# DS-K1T680 Series MinMoe Terminal Release Note (2021-03-23)

Device Model:  DS-K1T680D(F)-E1  DS-K1T680D(F)W  DS-K1T680D(F)G  DS-K1T680D(F)G1  Naming Rule:	Firmware Version	ARM :  ACS_680_AI3_EN_STD_V3.2.3 _build210303  ACS_680_AI3_EN_NEU_V3.2.3 _build210303
D for M1 card, Desfire card, Felica card E1 for POE W for Wi-Fi F for fingerprint	SDK	HCNetSDKV6.1.5.15_build2020 0713_win32_EN
G1 for 3/4G, supported in Australia, Taiwan (China) and Latin America; G for 3/4G, supported in Europe, the Middle East, Africa, India, and Most Areas of Asia-Pacific (excluding Japan and Taiwan (China))	iVMS-4200 Version	Latest version

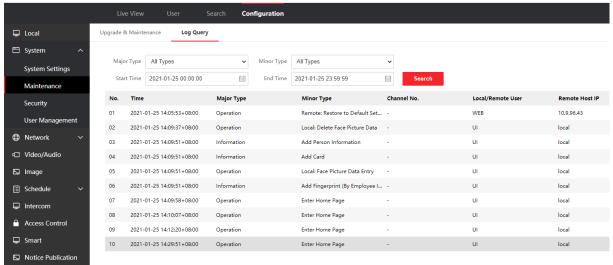
4. Add device operation log query function in web interface (login device in browser), we can check the device operation log from here.

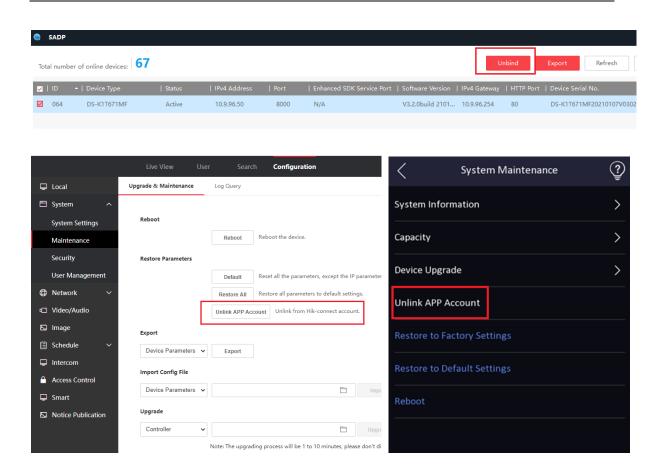
5. Add ISAPI event monitoring upload (HTTP listening) function

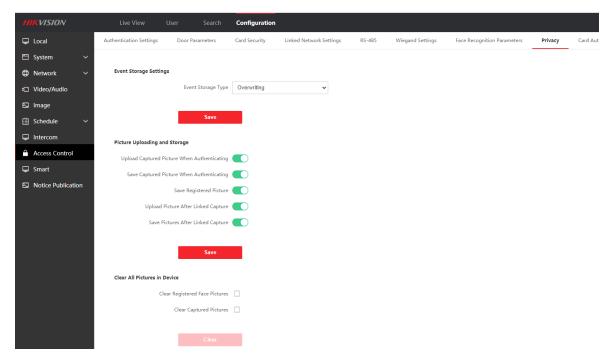
6. Support unbind device with hik-connect account on SADP tool, local UI and web

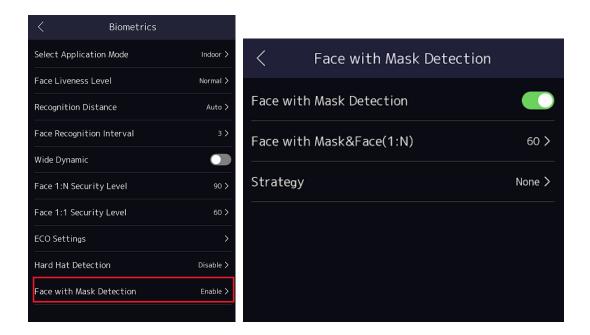
7. Add privacy protection, support event Storage Settings, Picture Uploading and Storage, Clear All Pictures in Device

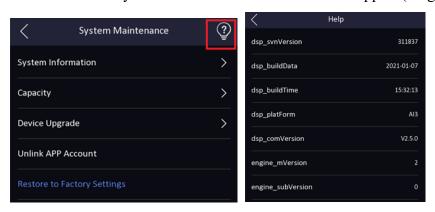
8. Add face mask detection function(enabled in default);

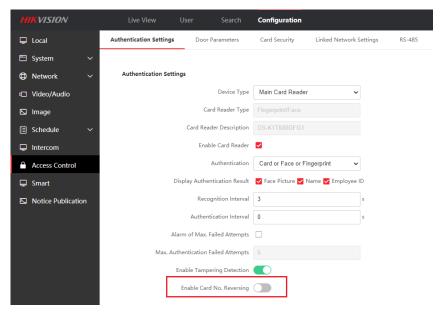
9. Add help interface to check system module version for technical support (long press for 3s).

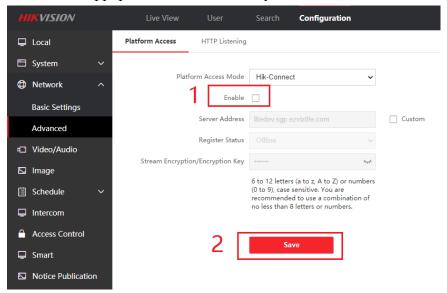
10. Add card No. reversing function (external reader not support)

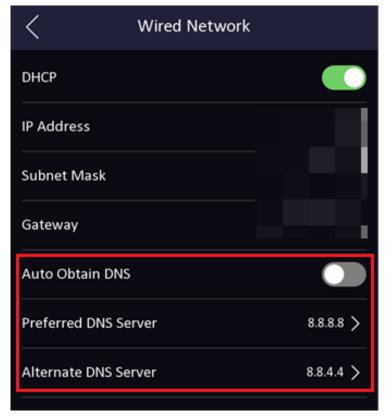
1. Hik-Connect function is turned off in default for privacy protection, if customer want to manage device from App, please turn on manually in the web.

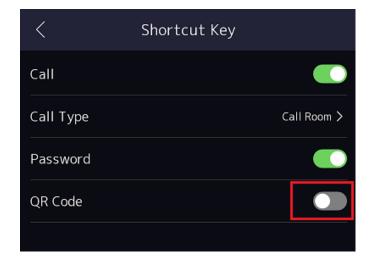
2. DNS can be configured from device UI in menu→Comm.-->Wired Network

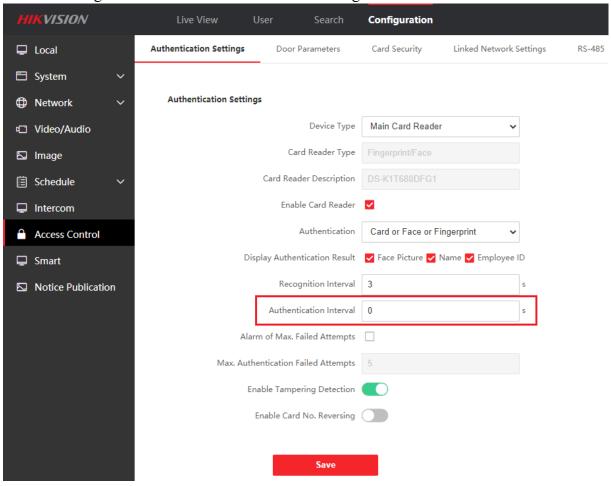
3. After disable QR code shortcut from the menu, device will support QR code and face verification at the same time.
